# St Ives Indoor Sports Complex

## Stage 2 Acoustics DA report

Job No: 1026651  
Doc Ref: RPT-AS-001  
Revision: C  
Revision Date: 10 June 2021

<b>Project:</b>	St Ives HS Stage 2 & 3	<b>Project No.</b>	1026651
<b>Subject:</b>	Response to Council RFIs	<b>Doc No.</b>	CAN-AS-001
<b>Author:</b>	Patrick Carpenter	<b>Date:</b>	23 November 2021
<b>Attention:</b>	Katherine Madden	<b>Revision:</b>	C

Figure 1 Provided traffic flow data

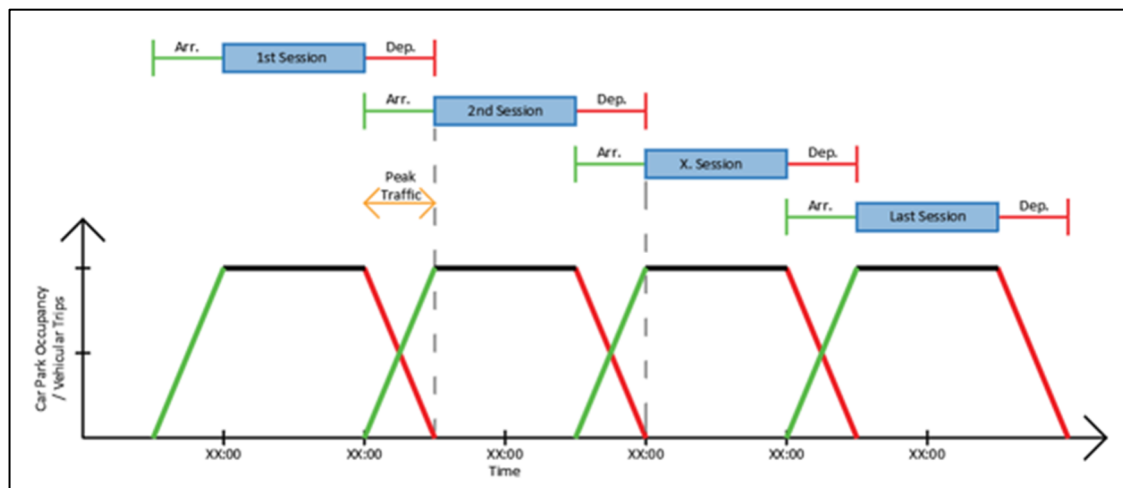
*Vehicle noise – the acoustic assessment has identified lower background noise levels in the evening and night however it does not identify or comment on potential noise impacts to residents from the movement of vehicles to or from the carpark in the evening or night particularly if use after 10pm is approved.*

Traffic modelling indicates that noise from vehicle movements and sporting activity will peak at different times, so we have not considered the impact from each concurrently, refer to Figure 1.

We have developed an acoustic model using SoundPlan proprietary software to predict noise due to the increase activity of traffic to the proposed gym carpark.
